BAR #2025-00370
Old and Historic Alexandria District
City Council
January 13, 2026

ISSUE: Appeal of a decision of the Board of Architectural Review approving a Certificate of Appropriateness for alterations in the Old and Historic District (OHAD) with conditions

LOCATION: Old and Historic Alexandria District
301 King Street

Figure 3: Proposed restoration of historic portion of building

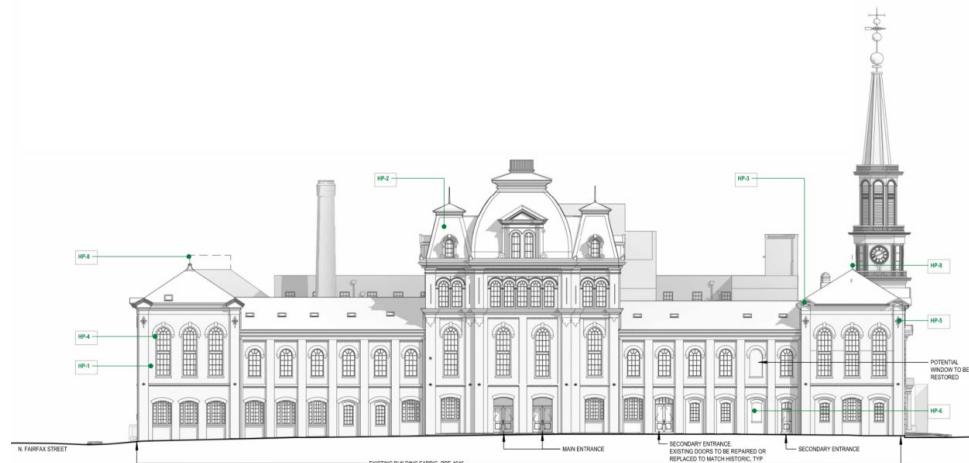
The historic portion of the building represents one of the most important historic and civic structures in the City of Alexandria. A variety of modifications and repairs to the building have been made over the decades, some of which have been consistent with the original design while others have obscured the historic elevations. The proposed restoration will reverse the more destructive modifications and restore the building to the original design intent as closely as possible (Figure 3).

The existing slate roof will be removed throughout; once water infiltration issues are identified and resolved, any slate that can be salvaged will be reinstalled and new slate to match the existing will be installed where it cannot be salvaged. Using historic photographs, the design team has identified the original decorative patterns on the historic roof and will be re-creating them upon replacing the roof. Also using the historic photographs, the team will be recreating the original roof cresting at the building corners. In addition to new roofing, copper flashing, downspouts, and gutters will be installed throughout.

The existing windows and doors throughout the building are not original to the structure and in many cases do not resemble the original configuration. Windows and doors throughout the Early portion of the building will be replaced. Using historic photographs, the team will be recreating the original muntin configurations to the greatest extent possible. The *Design Guidelines* state for Early buildings “On street facing sides, windows should be single pane wood.” The design team proposes to use wood windows with vacuum insulated glass throughout. These windows are an emerging technology that places two layers of glass in close proximity to one another, separated by a vacuum. This is different than the traditional double pane glass where the panes are separated by a spacer bar and an inert gas. Staff supports the use of these windows, finding that unlike traditional double pane windows, this product closely resembles the original single pane windows while providing a level of thermal performance that is required of a modern building. Staff recommends that the applicant work with historic preservation staff during construction to ensure that restoration materials match the historic materials in color and texture.

- b. Work with historic preservation staff during construction to ensure that restoration materials match the historic materials in color and texture.

Figure 8: Proposed layout for Market Square

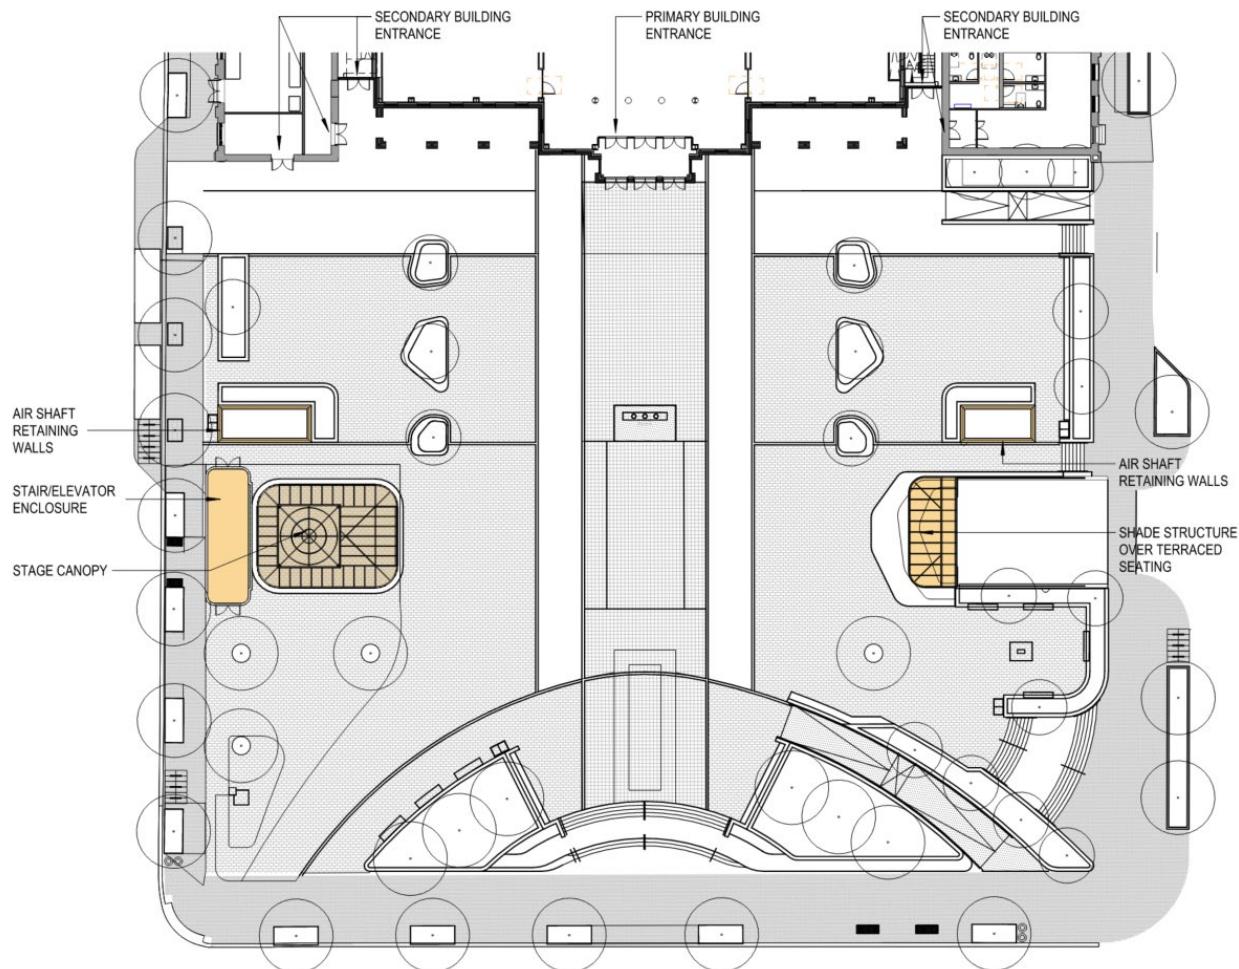
This standard is most relevant when considering the layout of Market Square. The layout is organized around a central axis extending from the main building entry to King Street. A series of curved planters and stairs adjacent to King Street creates a dynamic entry to the plaza which is more rigid and rectilinear. The plaza includes a series of “outdoor rooms” along the east and west sides which bring the scale of the space to a pedestrian level. An east-west axis is created through the construction of shade structures on either side of the plaza. A glass and brick enclosed structure on the west side of the plaza encloses the elevator entry to the parking garage below (Figure 8).

Staff finds this configuration to be consistent with the formal nature of the existing building and compatible with other nearby historic structures. This layout also creates a pedestrian friendly streetscape by providing multiple entry points to the plaza and eliminating many of the large retaining walls currently found on the site.
